Laurel Heights Improvement Association of San Francisco, Inc.

October 23, 2018

Re: State Clearinghouse No: 2017092053 - 3333 California Street Project
Application for Environmental Leadership Development Project

C2.02

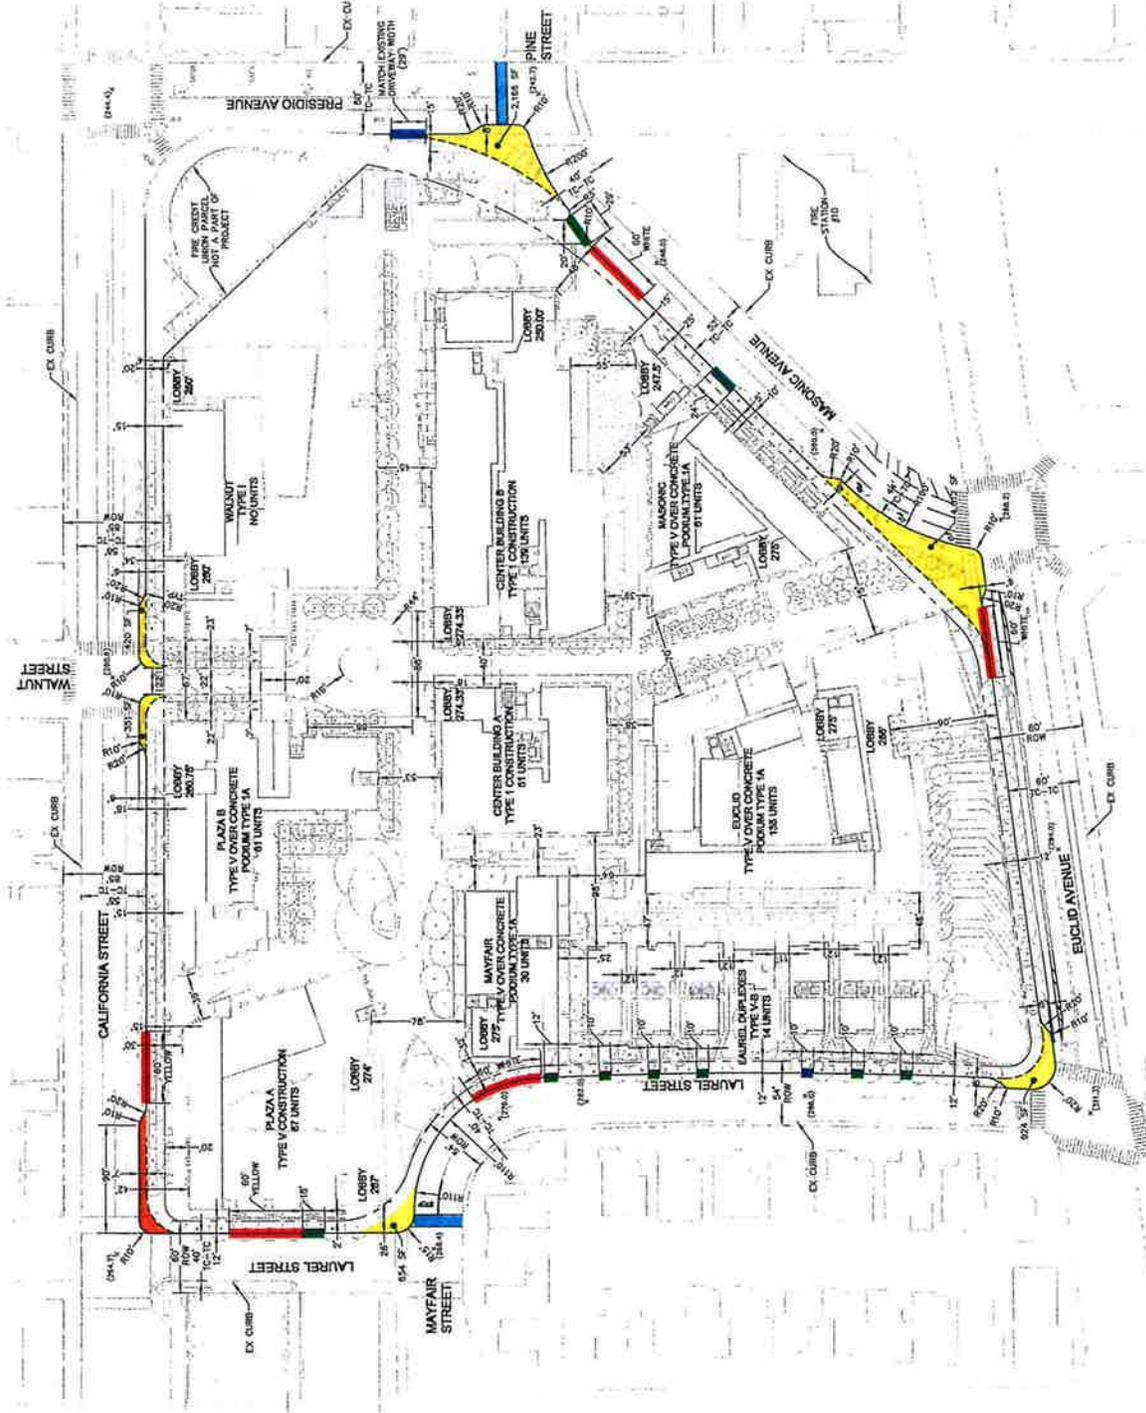
The project drawings submitted with the application do not show the new passenger and commercial loading zones proposed for the exterior of the site, which would be used for pick-ups and drop-offs by passenger and commercial vehicles, including transportation network companies such as Uber and Lyft. These passenger loading zones can be expected to be used by employees working at the site as well as residents and visitors.

Attachment A hereto contains the 8-17-2017 plan sheet C2.02, which shows four (4) new proposed passenger loading zones and one (1) new commercial loading zone marked in red on the exterior of the site. Plan sheet L1.01 shows them marked in blue. (See Attachment A)

G2.08

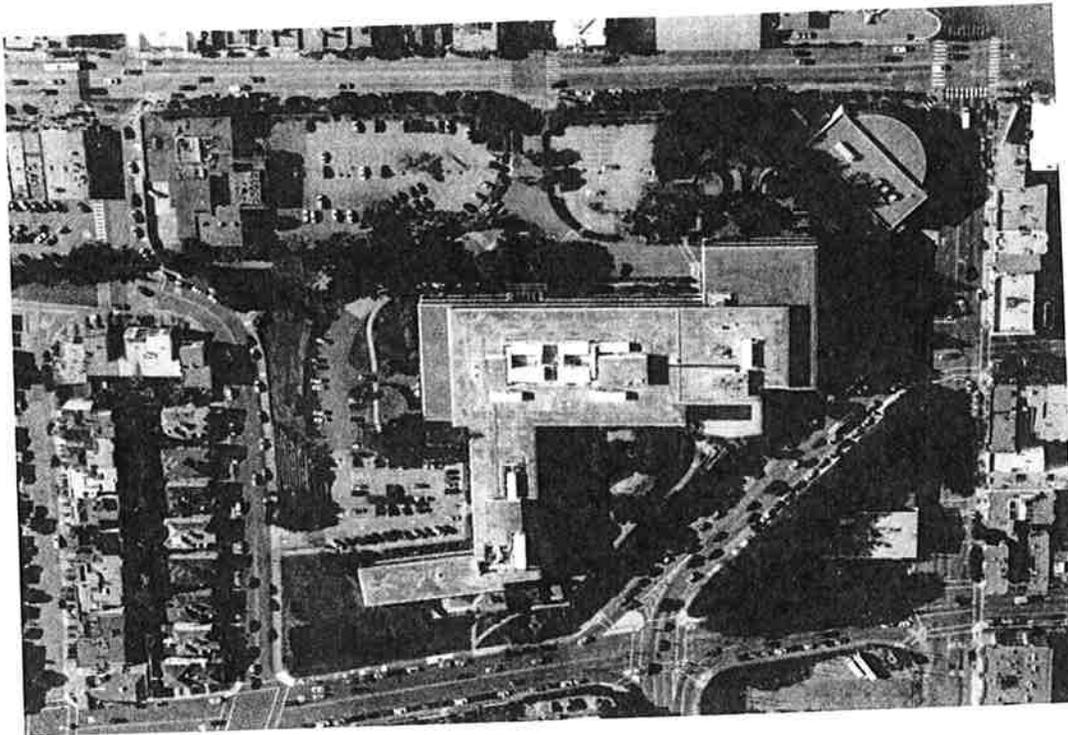
Public Resources Code section 21183(c) specifies that the project may not result “in any net additional emission of greenhouse gases, including greenhouse gas emissions from employee transportation.” The statute does not limit the GHG emissions to direct emissions from the project. All indirect emissions should also be evaluated, including the GHG emissions that would result from the manufacture of the substantial amounts of concrete and steel that would be used to construct the proposed and variant projects. The project proposes to construct 1,372,270 gross square feet of development on the site, which is almost three times the existing 469,000 gross square footage of development. (See Attachment C, plan sheet G3.02a and excerpt of Initial Study for 3333 California Street Mixed Use Project, p. 9) Substantial amounts of concrete and steel would be needed for construction of underground parking garages, which would entail excavation of soils and rock 7- 40 feet below existing grade, generating approximately 241,300 net cubic yards of excavated soils. (See Attachment C, Initial Study excerpt, p. 207 and plan excerpt G2.08.)

A6.00

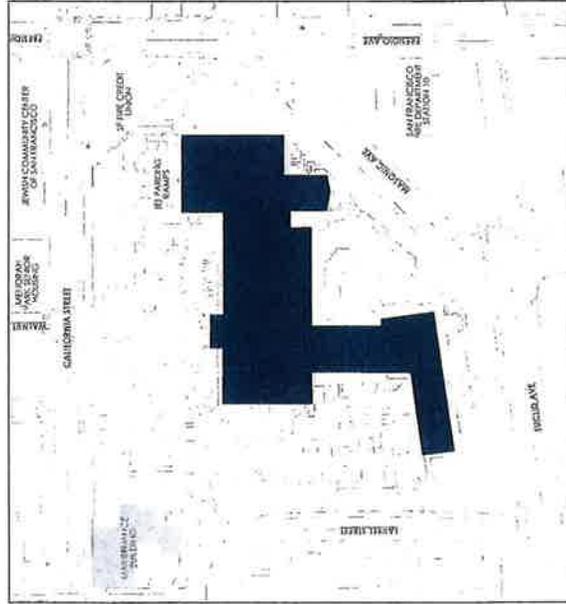
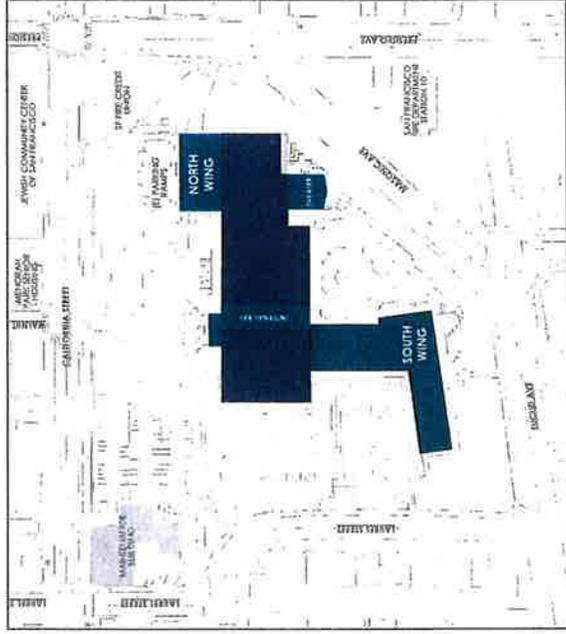
The proposed and variant project would materially impair character defining features of the resource including the horizontality of massing and the integrated landscaping. (Attachment G, plan sheets A6.00, A6.01 and A1.02)
